Re: South Central Waterfront Combining District & Density Bonus Program

South Central Waterfront

Interdepartmental Responses to 5/14/24 Developer Letter

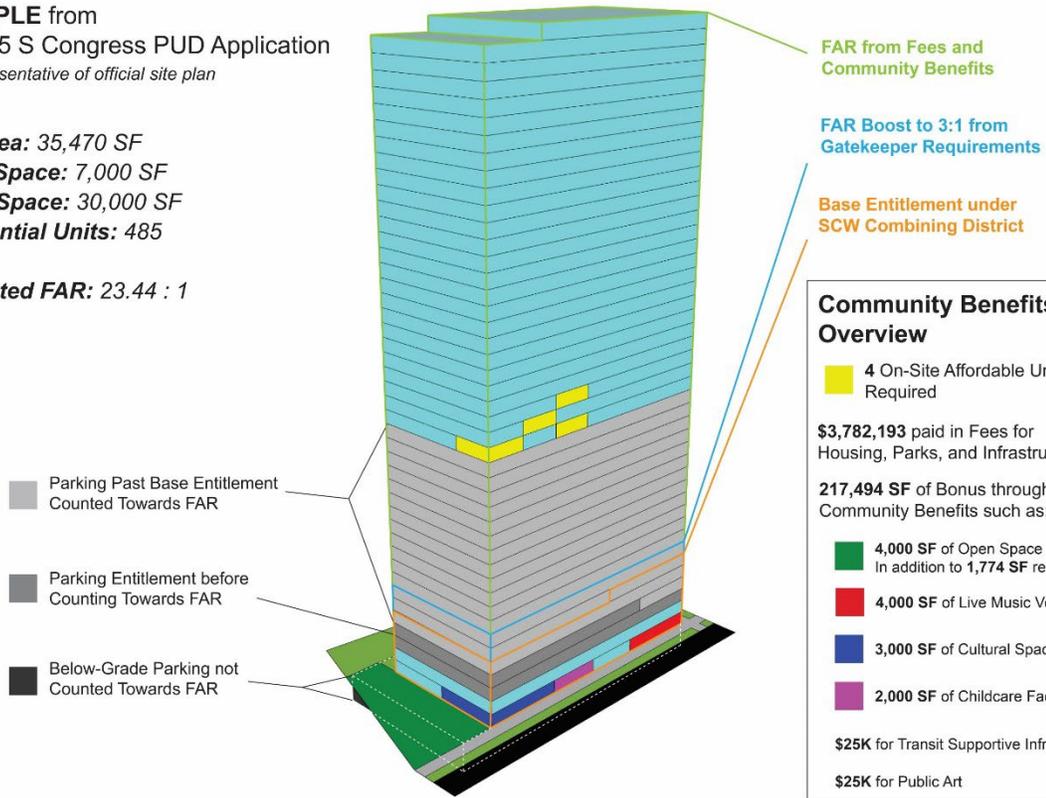
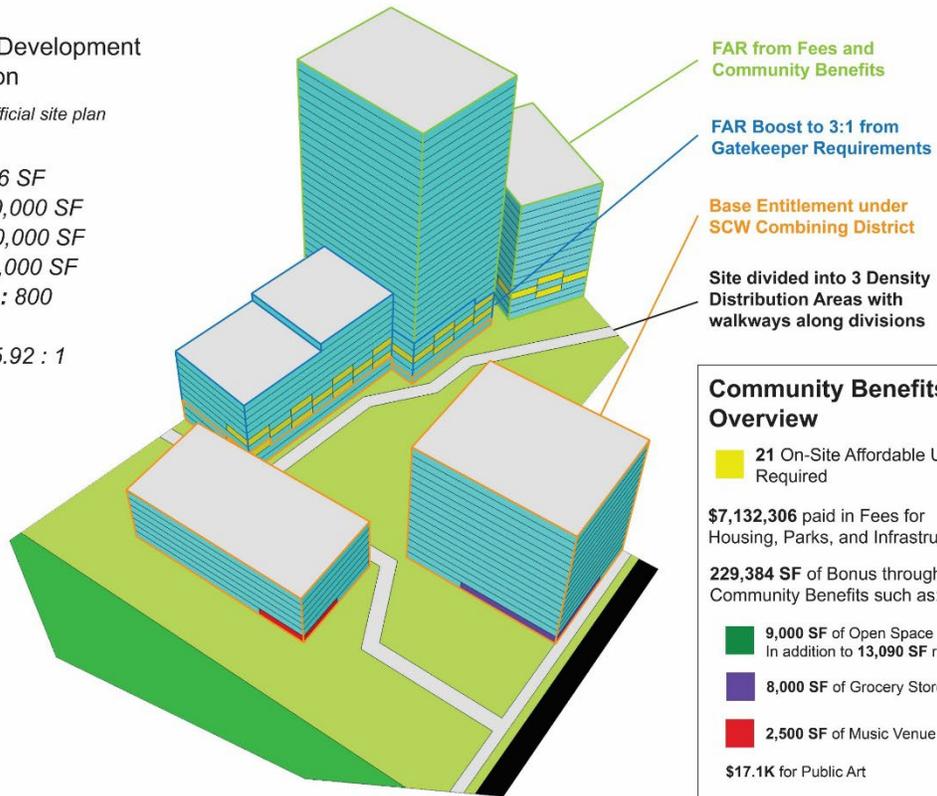
3. The plan lacks sufficient information to fully understand the feasibility of meeting the onsite community benefits required to exceed 5:1 FAR.

Through participation on the SCW density bonus program, additional entitlements are gained by providing onsite community benefits with small or negligible space requirements such as affordable childcare and adult care or public art. The latter benefit can be a mural or similar installation or an interactive sculpture—all of which require very little space. Additionally, parkland buildout and transit supportive infrastructure buildout are not required to be onsite and could be applied to public land within the SCW district. Onsite community benefit applications have been tested for 311-315 S. Congress Ave. and 500 S. Congress Ave. sites to provide examples of successful implementation. These examples can be found below.

Non-residential bonus rates were calculated to represent a cost of approximately \$9/sf of bonus area through the construction costs of the selected community benefits and/or the loss of rent compared to a market-rate tenant for benefits such as affordable creative space, childcare, grocery, etc. This fee is consistent with the nearby Downtown Density Bonus Program's Base CBD zoning density bonus.
